Sicherheitsmitteilung 040902

Herstellerbulletin: N°04/002 von 23/08/04

Betrifft: Umlenkklappe (Deflector flap)

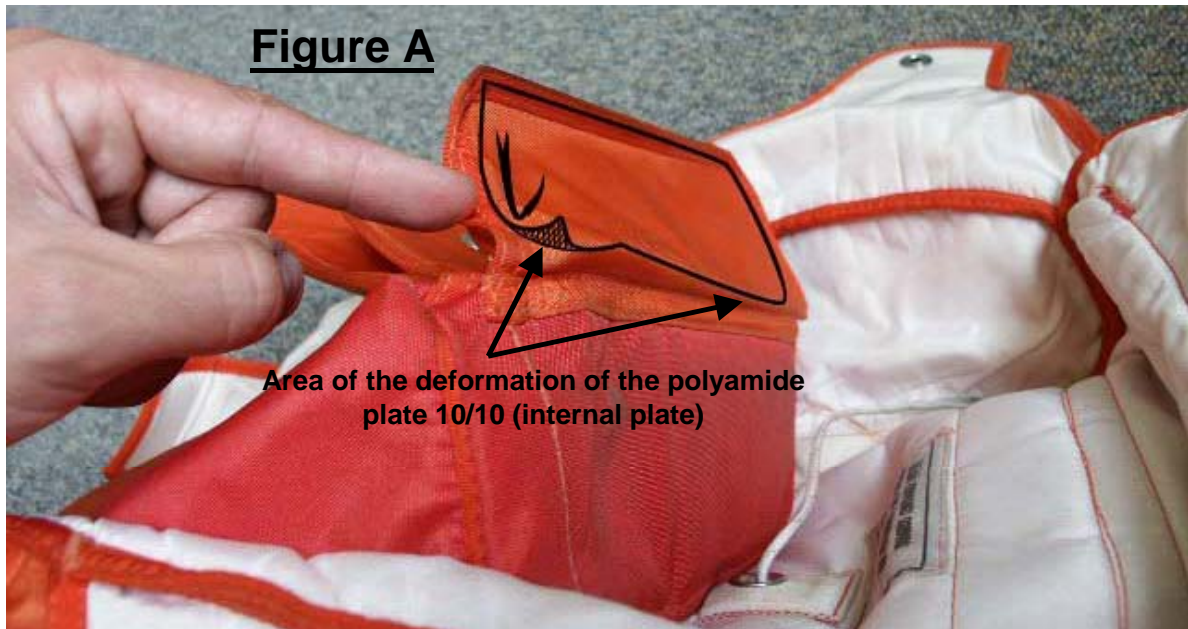
A deformation of the polyamide plate 10/10 (internal plate) of the deflector flap may occur near the sewing that binds the deflector flap to the container (see figure A).

Depending on the way the deflector flap is placed on the main deployment bag during the packing process, it may be deformed in time and its efficiency may be reduced.

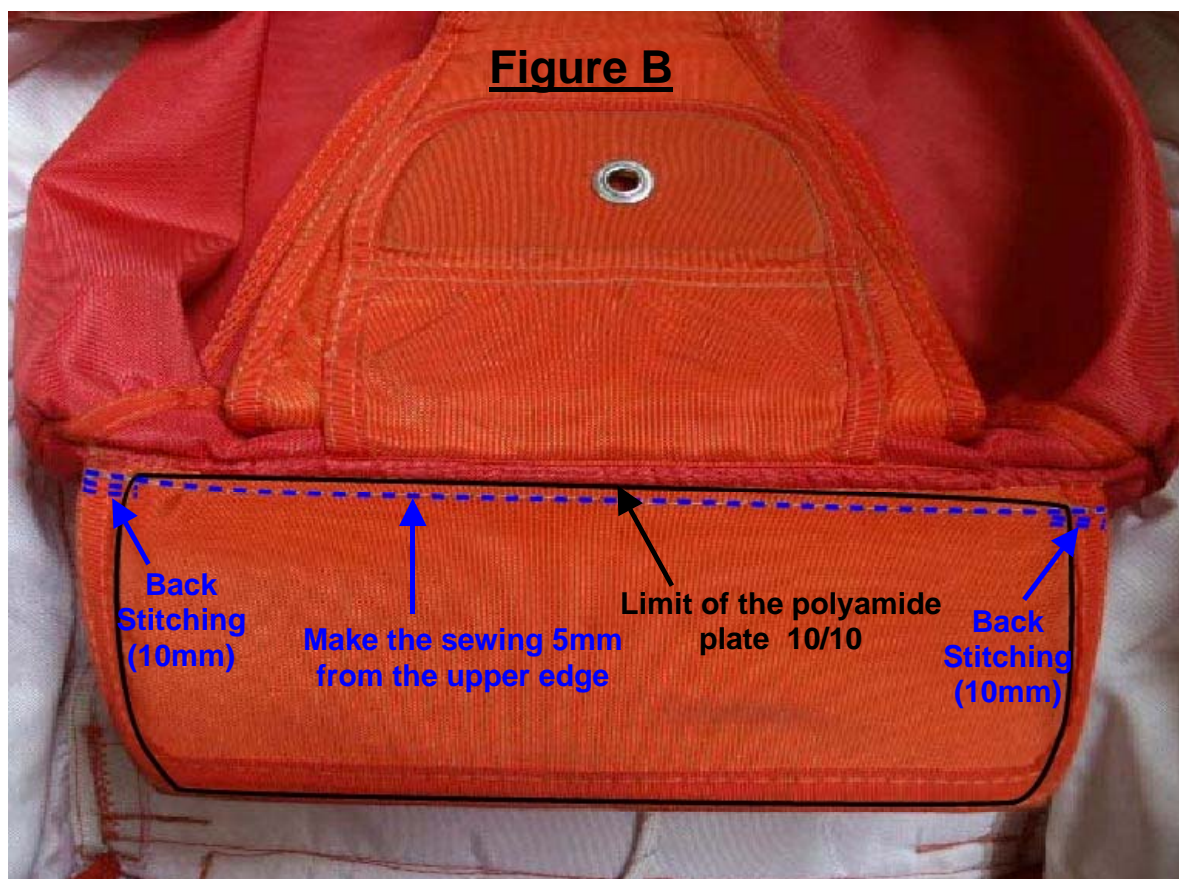
Case N°1 : In the event of a deformation as shown on figure A : Before using the equipment again, get a qualified rigger to make a sewing on the deflector flap as shown on figure B.

Case N°2 : In the event of an absence of deformation : As a precaution, also get a qualified rigger to make a sewing on the deflector flap as shown on figure B during the next repacking of the reserve canopy at the latest.

Make a sewing all along the deflector flap (normal stitch) making sure that the polyamide plate 10/10 (internal plate) is included in the sewing. (The reserve canopy needs to be removed from the reserve container).

- Use polyamide thread 66 strength up to 6 kg (ref PF 9002402000 : Thread for container (30/3) or any equivalent),
- make 5 to 6 stitches every 2 cm,
- make it 5 mm from the edge,
- make two 10mm back stitching at the both ends of the sewing.
